DOC21/286334

School Infrastructure NSW (SINSW) on behalf of the Department of Education (DoE) is seeking to modify Conditions A2, C22(c), D5 and D33(c) of the development consent for the Picton High School Redevelopment (SSD 8640) pursuant to section 4.55(1A) of the *Environmental Planning and Assessment Act 1979*.

Proposed Revisions to Conditions of Consent

Figure 1: Tree Inspected by Horticultural Management Services and subsequently removed with the approval of Wollondilly Council

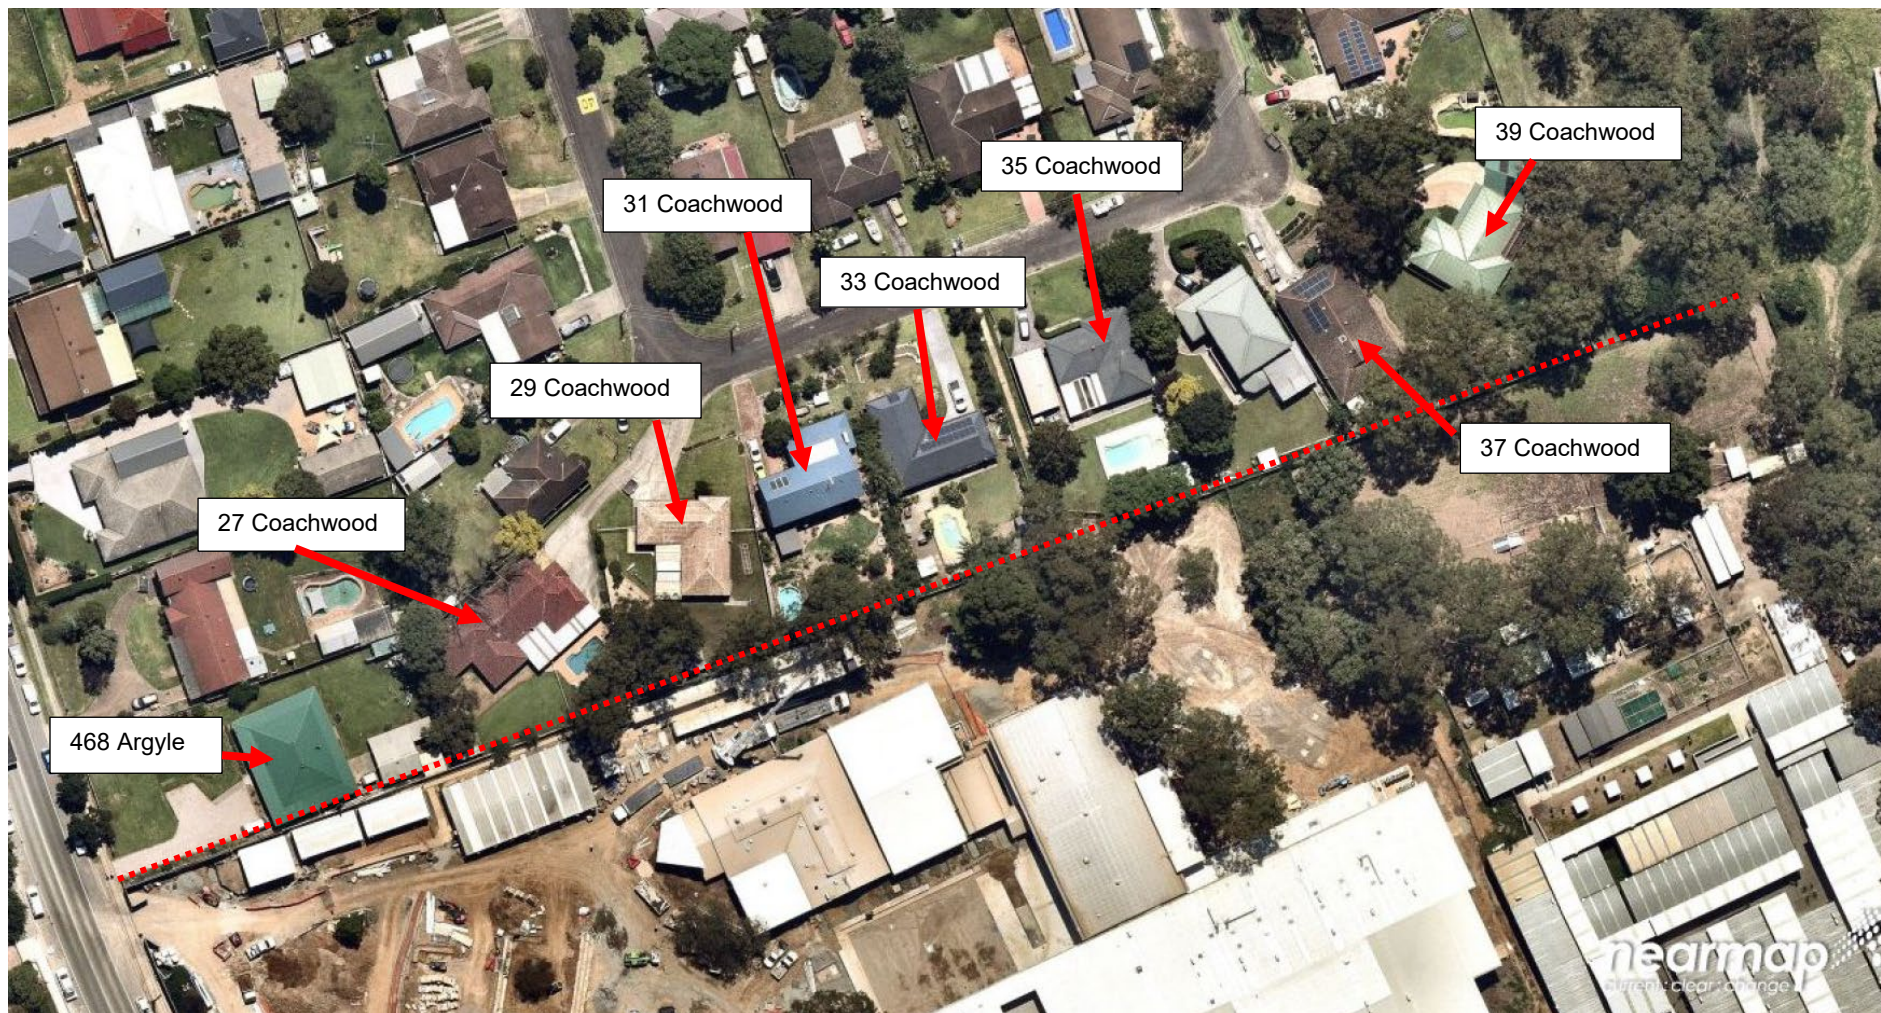
On 16 October 2019, Horticultural Management Services conducted an inspection of a (then) existing Red River Gum tree (*Eucalyptus camaldulensis*) located adjacent to Building B (see **Figure 1**).

The inspection concluded the subject tree was in poor health and structural condition as a result of what was likely to have been a lightning strike and recommended that it be removed to address work health and safety concerns. A copy of correspondence from Horticultural Management Services is included at **Attachment 2**.

Proposed Revisions to Conditions of Consent	Discussion / Justification
D36. Prior to occupation of the building, the Applicant must prepare a Landscape Management Plan to manage the revegetation and landscaping works on-site, to the satisfaction of the Planning Secretary. The plan must: (a) Include revised landscape plan as per condition B4 to include planting in accordance with the approved Softscape Tree Size Specification & Formal Softscape Areas (Issue B C) prepared by Arcadia Landscape Architecture dated March 2019 November 2020 and at least 14 additional canopy trees; (b) detail the species to be planted on-site; (c) include details of the area surrounding the education trail is to be rehabilitated with local native plants; (d) include details that the native trees to be removed from the site are to be salvaged, including tree hollows and tree trunks (greater than 25cm in diameter and 3m in length) and used to enhance habitat at the site; (e) include details of the installation of artificial nest boxes which are suitable to native fauna; (f) detail that the seeds from native plants to be removed is collected and used in the landscape area; (g) provide an ongoing weed control and maintenance program to maintain the existing and new remnant native vegetation; (h) describe the monitoring and maintenance measures to manage revegetation and landscaping works; and (i) comply with the principles of Appendix 5 of <i>Planning for Bush Fire Protection 2006</i>.	SINSW seeks approval to amend Condition D36 to update the approved Tree Size Specification and Formal Softscape Areas to reflect the removal of the subject tree and the planting of three (3) replacement trees in its previous location. Amended landscape drawings are included at Attachment 4.
